Planning & Development Report to  
Calgary Planning Commission  
2020 August 06

ISC: UNRESTRICTED  
CPC2020-0460

## Land Use Amendment in Spruce Cliff (Ward 8) at 712 Poplar Road SW, LOC2019-0199

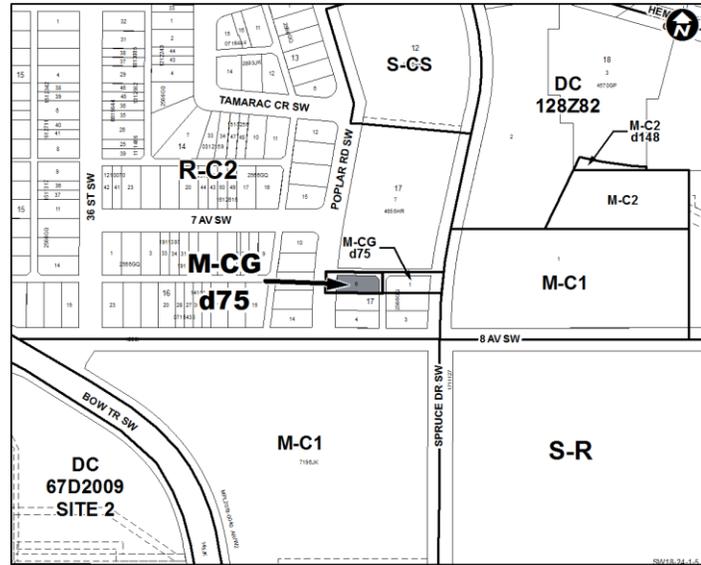
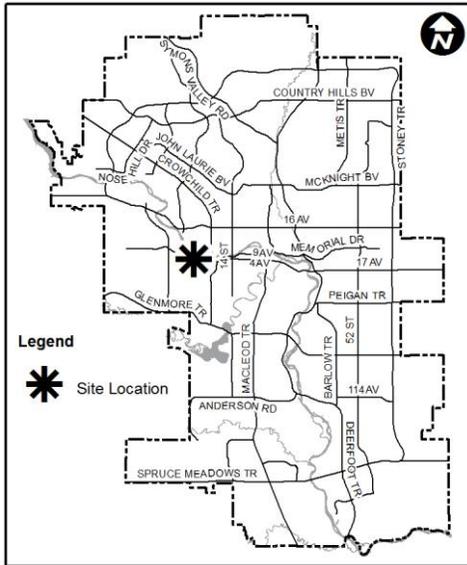
Administration does not support the development permit as proposed, as it does not align with the height, scale, setbacks and massing of the R-CG District as detailed below in the Investigation: Alternatives and Analysis section of this report. Therefore, Administration recommends that the Calgary Planning Commission recommend to Council that this land use application be refused.

As outlined in the Applicant's Outreach Summary (Attachment 2) the applicant elected to pursue an M-CG District land use and a concurrent development permit (DP2020-2096) that followed the height, scale, setbacks and massing of the R-CG District. However, when the proposed development permit in Attachment 3 was reviewed against the rules of the R-CG District, the following significant built form and contextual deficiencies were identified:

- 540(2) Building Setback - Plans indicate the setback from the adjacent parcel (south) is 2.0 metres (-1.0 metre) for the portion of the building located past 50 percent of the parcel depth.
- 541(1) Building Height - Plans indicate portions of the building exceeds the 11.0 metre height.
- 541(2) Building Height - Plans indicate the building projects into the chamfer from the adjacent parcel on the south elevation.
- 541(3) Building Height - Plans indicate the third storey exceeds 75 percent floor plate reduction at horizontal cross section by 22 percent (third storey is 97 percent or 3 percent small than at cross section).
- 535(2) Building Depth - Due to the location of the building being less than 3.0 metres from the property line shared with the adjoining parcel (south), this rule is non-compliant.

Cumulatively, the above noted deficiencies indicate that the proposed development does not follow the rules R-CG District but rather has followed the rules of the M-CG District.

percent of the parcel depth or rear façade of the adjacent development in the R-CG District. The sizable increase in mass of the third storey and proximity of a proposed three-storey wall to the adjacent neighbour to the south allowed under the M-CG District is not sensitive to the adjacent and surrounding context. Therefore, Administration is recommending refusal of this land use application.

From Administration's perspective, the root cause of a number of the deficiencies identified in the proceeding section are as a result of the proposed attached drive under garages. The attached garages push the living space of each unit back towards the adjacent neighbour and up to a (full) third storey. Administration does not support the development permit as proposed, as it does not align with the height, scale, setbacks and massing of the R-CG District as detailed above in the Land Use section of this report. Therefore, Administration does not support this land use application.

If this application is refused by Council, the applicant can withdraw the concurrent development permit, or it will be refused by Administration. The applicant can then reapply for a DC(R-CG) land use, which Administration would support.
